Access Compliance Report

Public Rights-of-Way

(Curb Ramps)

Intersection ID: 53713	Main Street: N_TRYON_ST	Cross Street: PERIWINKLE_HILL_AV	Location: E
ADA ID: AEB8CCF3E7A5	Ramp Type: BlendTrans1	Initial Pass/Fail: Pass	Overall Compliance: No
Severity Score: 5			
Codes/Mitigation Info/Possible Solution		Field Measurements/Component Compliance

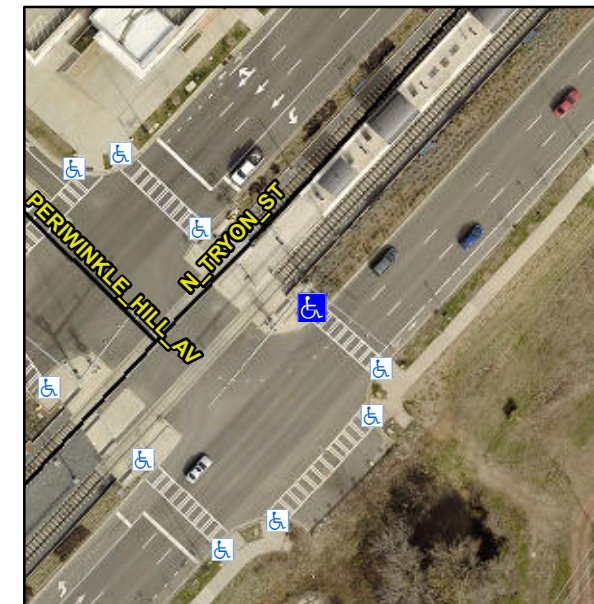
**Remove & Replace Curbed Edge.
Remove & Replace Gutter.**

R304.2.3, R304.5.3

Compliance	Description	Data	Compliance	Description	Data
N/A	Ramp Length (in)	114.0	Yes	BlendTrans Slope (%)	1.0
Yes	Ramp Width (in)	116.0	Yes	BlendTrans XSlope (%)	1.4
No	Flare Type	Curbed_WithWalkSurface	Yes	Flare Type	Curbed_NoWalkSurface
N/A	Flare Slope LT (%)	N/A	N/A	Flare Slope RT (%)	N/A
N/A	Flare Traversable LT?	No	N/A	Flare Traversable RT?	No
Yes	Landing Length (in)	93.0	Yes	DWS Provided?	Yes
Yes	Landing Width (in)	114.0	Yes	DWS Contrast?	Yes
Yes	Landing Slope (%)	1.6	Yes	DWS Length (in)	24.0
Yes	Landing X Slope (%)	0.9	Yes	DWS Full Width?	Yes
N/A	Landing Curb? (Y/N)	Yes	Yes	DWS Offset (in)	0.0
N/A	Shared Landing?	No			
Yes	Gutter Ponding?	No	Yes	Gutter Slope (%)	0.3
Yes	Gutter Lip Ht (in)	0.0	No	Gutter X Slope (%)	3.4
N/A	Painted X Walk1?	Yes	N/A	Painted X Walk2?	N/A
	X Walk 1 Direction	To SE		X Walk 2 Direction	N/A
	X Walk 1 Width (in)	106.0		X Walk 2 Width (in)	N/A
	X Walk 1 Slope (%)	1.9		X Walk 2 Slope (%)	N/A
